Service Bulletin

Bulletin No.: 20-NA-020

Subject: Brake Squealing Noise

Brand:	Model:	Model Year:		Breakpoint:		Engine:	Transmission:
		from	to	from	to		
Chevrolet	Silverado 2500HD/ 3500HD	2020	2021	—	—		
GMC	Sierra 2500HD/ 3500HD

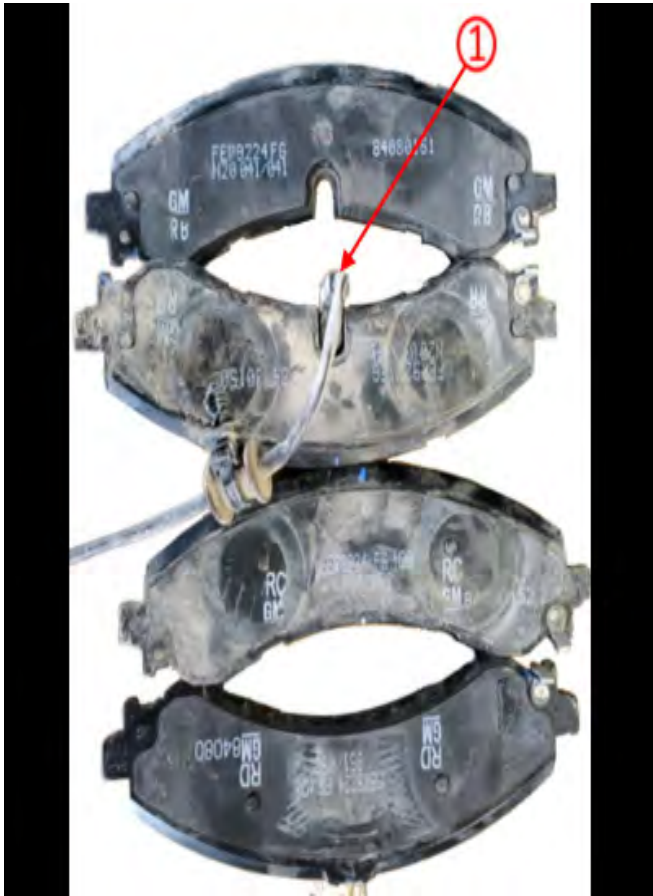
Involved Region or Country	United States, Canada, Mexico, Middle East, Israel
Condition	Some customers may comment that the brakes are squealing.
Cause	This condition may be caused by a low scorch friction material was used on the original brake pads.
Correction	<p>Replace the front and rear brake pads.</p>  <p style="text-align: right;">5638981</p> <p>Note: Each brake pad is labeled with an Inner or Outer to indicate where to be installed.</p>

New pads have a "high scorch" friction material. Current parts in inventory are the new design.
 If the pads have already been replaced and the noise persists, check the orientation of the pads. There is an inboard and outboard designation on the pads. If they are in the wrong location, a brake noise can result.

Important: Only the left side of the truck has the wear sensors (1) and is mounted on the inner pad.
 Refer to *Front and Rear Disc Brake Pads Replacement* in SI.
